Permit Number 2911

Owner Temple Beth Or (Rectory for the Rabbi)

APPLICATION FOR PERMIT TO LOCATE AND CONSTRUCT AN INDIVIDUAL SEWAGE DISPOSAL SYSTEM

LOT 1 BLOCK 1995
 TOWNSHIP OF BRICK
 OCEAN COUNTY, N.J.
 SCALE: 1"=50' DATE: APR 1979

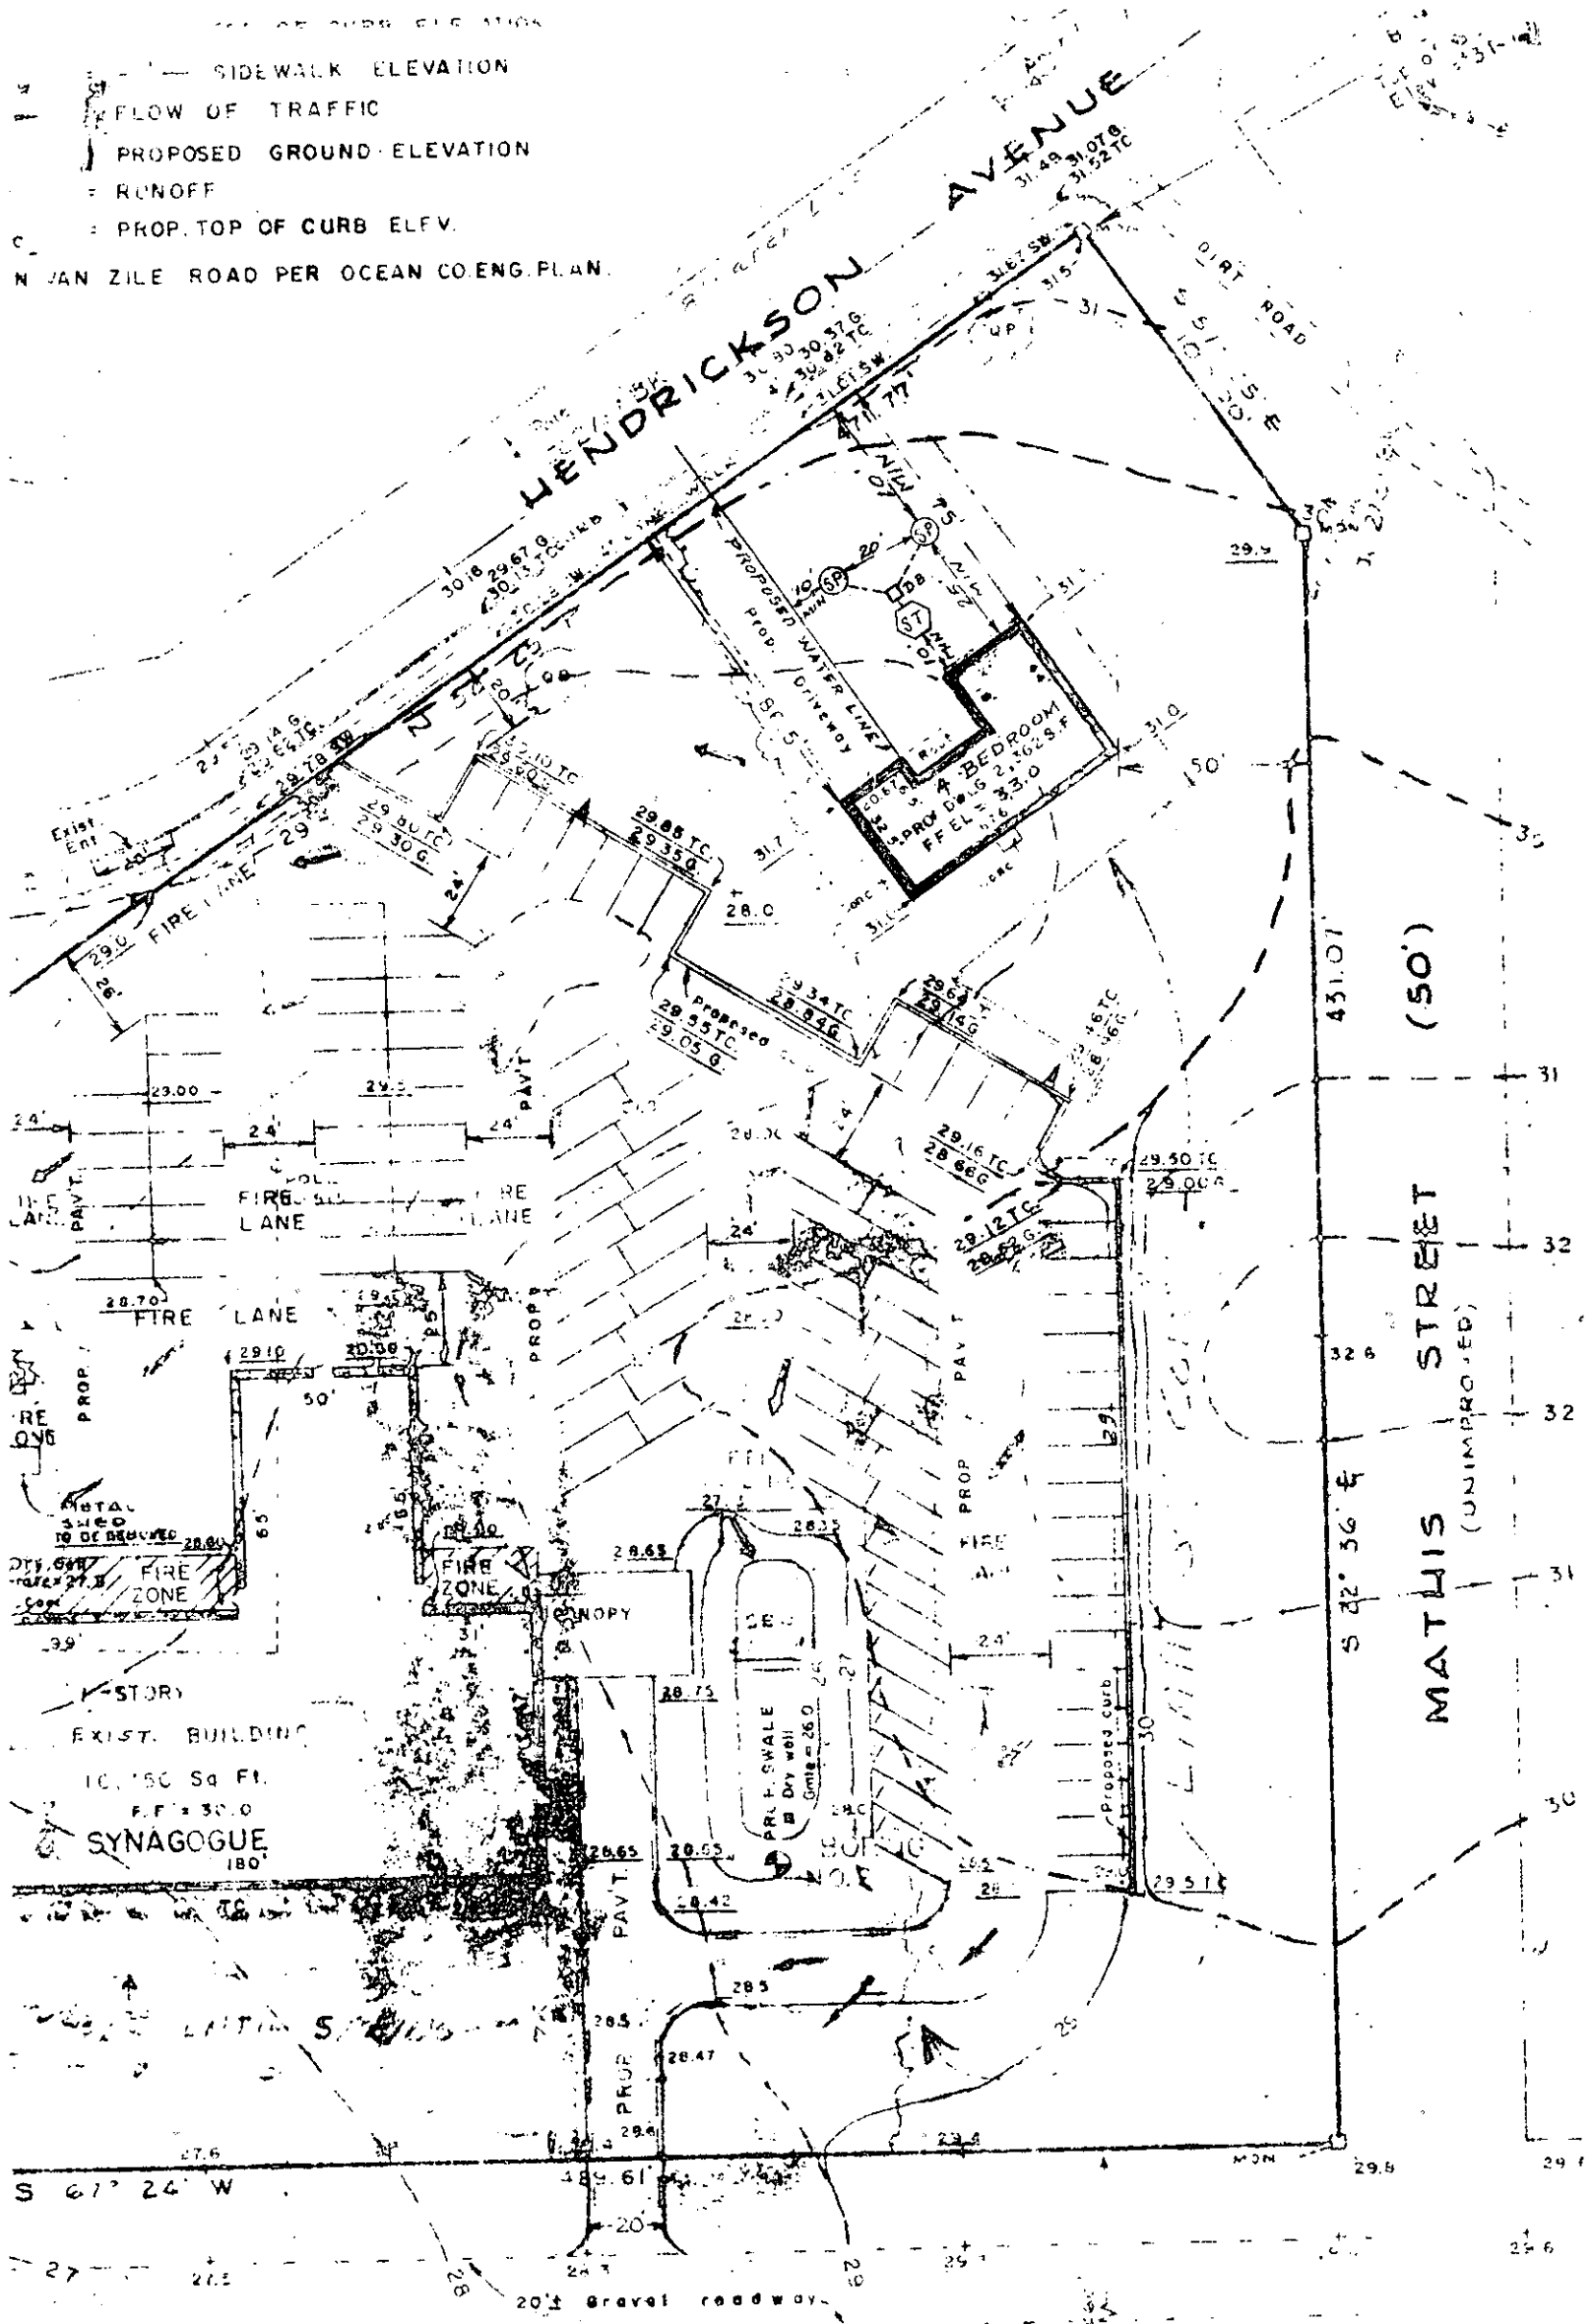
- H.D.26
- 1) Wrong pitch on elbow at entrance to (5)
 - 2) lines to (5) not set level in D-box
 - 2) Revised drawing showing 2 bldg sewers.
